VERIFICATION REPORT HYDROELECTRIC PROJECT EL EDÉN

Report ID	VCS_VerR_El Edén_1068_01JAN2021-31JUL2024_v3
Project title	Hydroelectric Project El Edén
Project ID	1068
Verification Period	01-January-2021 to 31-July-2024
Original date of issue	07-November-2024
Most recent date of issue	20-November-2025
Version	3
VCS Standard Version	4.7
Client	ALLCOT AG
Prepared By	AENOR CONFÍA S.A.U.
Approved by	Jose Luis Fuentes, Climate Change Manager

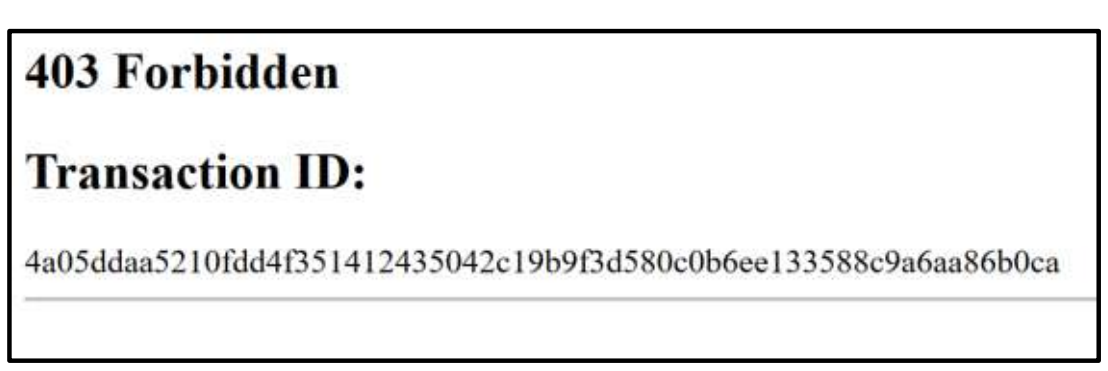
NC/CAR id.	02	Date: 24/01/2025
NC/CAR description		
The audit team has identified the following errors in the MR: 1. The website provided in page 28 "www.xm.com.co" does not work. 2. "Percent difference" represented in section 4.4 are not correct.		
Project Proponent's Response		**Date:** 25/02/2025
The website is working. Please try again. *Percents were corrected.*		
Documentation provided by the project proponent		
VCS MR Project ID 1068 01012021 – 31072024 V2		
VVB's evaluation		**Date:** 05/03/2025
1. **The website still has problems, when using the 'Ctrl+left mouse button' keys you should be able to access it directly**:

**403 Forbidden** **Transaction ID:** 4a05ddaa5210fdd4f351412435042c19b9f3d580c0b6ee133588c9a6aa86b0ca

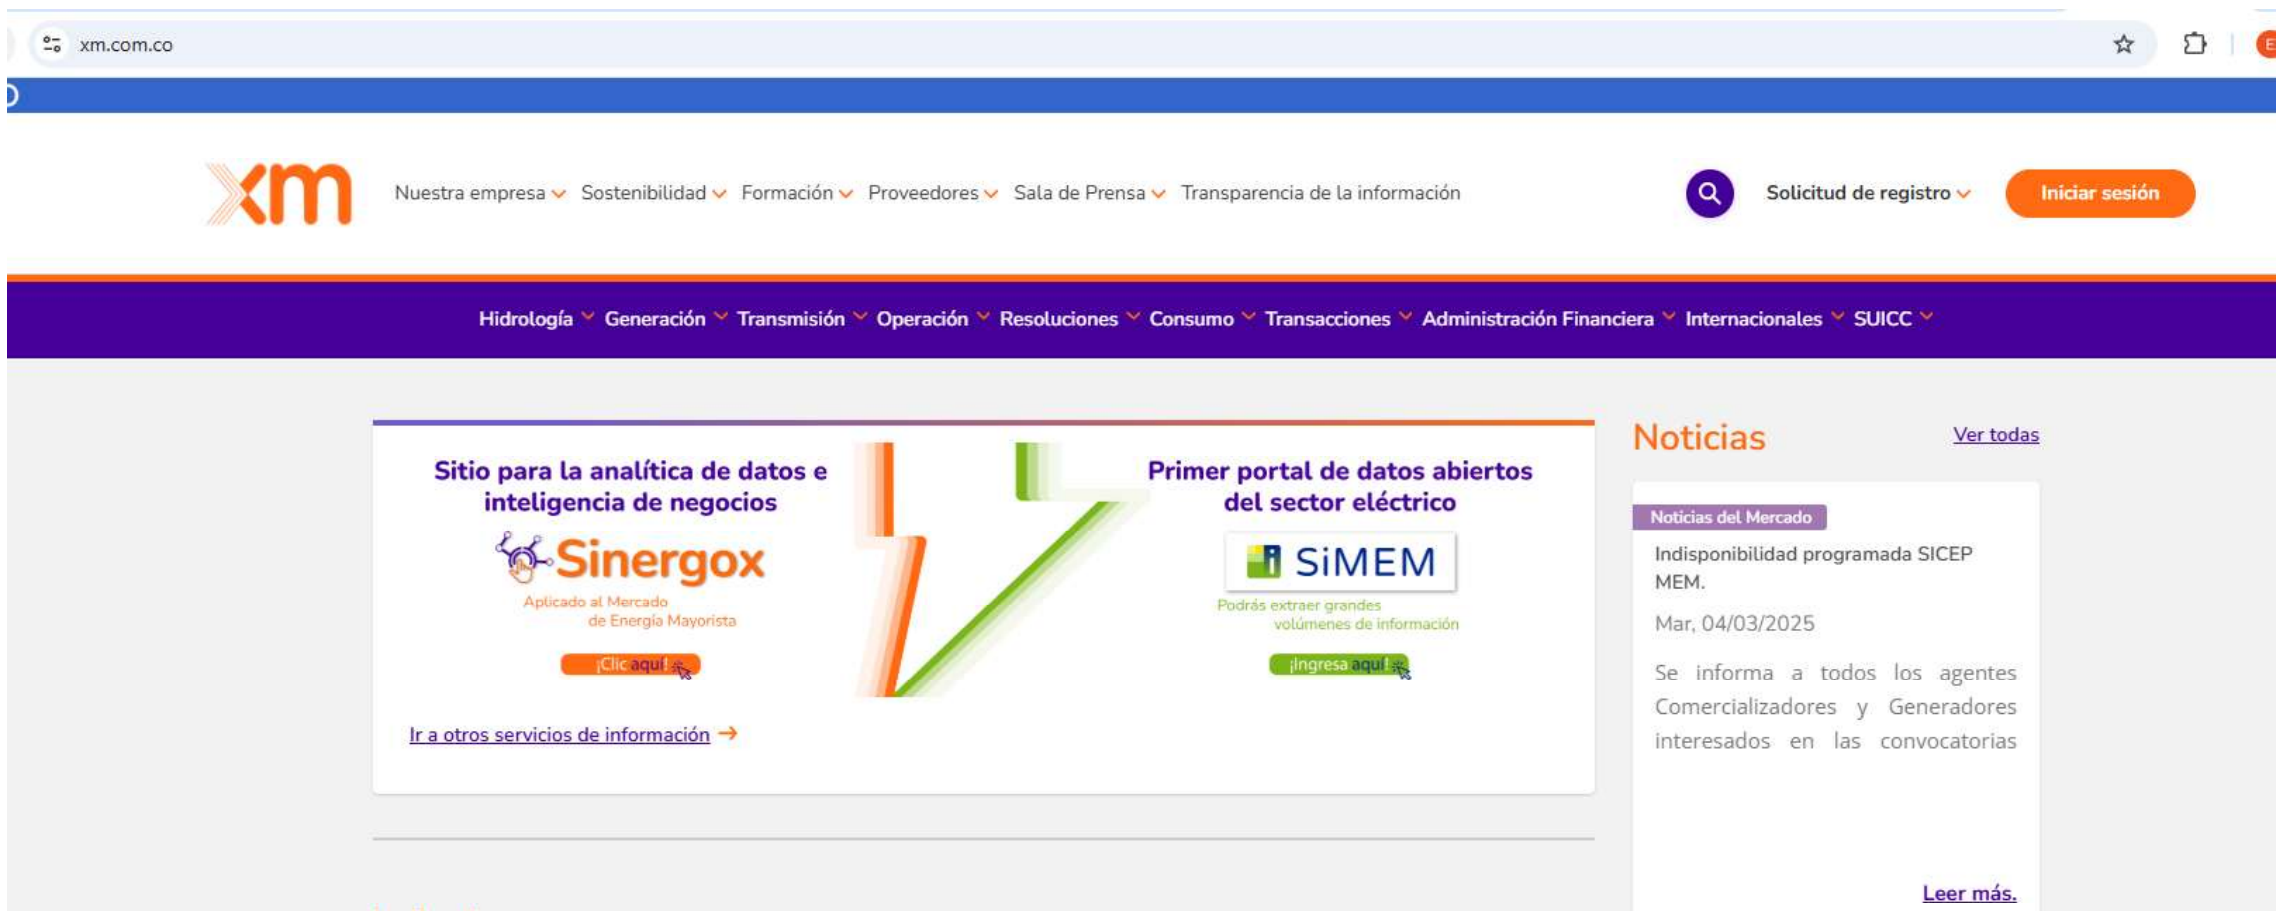
In my case, when using the "Ctrl+left button" keys, link directs me to the website.

Requested public website has been modified correctly in the updated MR v4.   **Therefore, CAR 02 can be closed.**
